GLOBAL SAFETY FIELD INVESTIGATIONS
DCS5276
URGENT - DISTRIBUTE IMMEDIATELY

Subject: N192282480 - Customer Satisfaction Program
Body Control Module Wiring Damage – US Only

Models: 2019 Buick Encore, Enclave
2019 GMC Acadia, Canyon, Sierra 1500 (New Model),
Yukon and Yukon XL
2019-2020 GMC Terrain

N192282480 Body Control Module Wiring Damage – U.S. Only

5480300

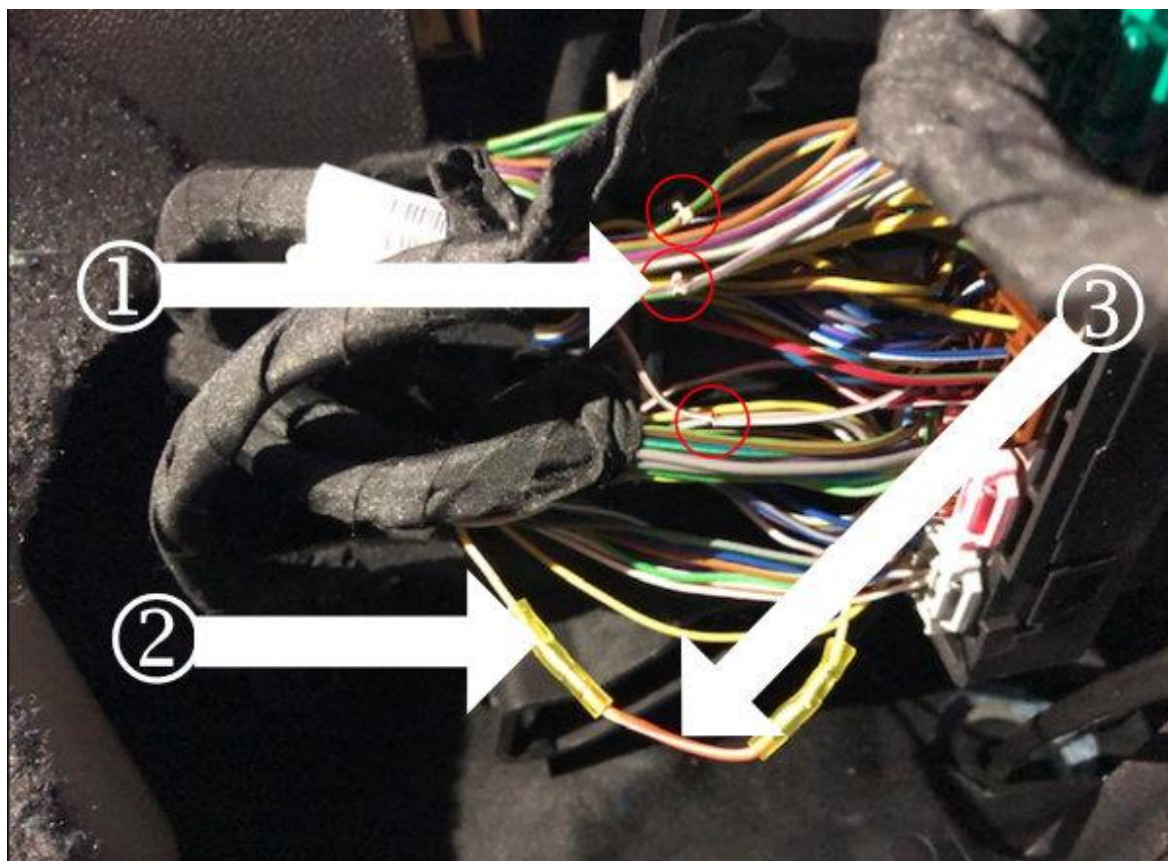
Inspect the knee bolster panel under the steering column for evidence of an aftermarket anti-theft module. This will show as:

- Screw holes, indicating that an anti-theft module was installed and has been removed. These vehicles require further repairs, refer to Repair Steps below.
- Anti-theft module installed, verify function of aftermarket system, no further action required.
- No evidence of any anti-theft device ever installed or removed, no further action required.
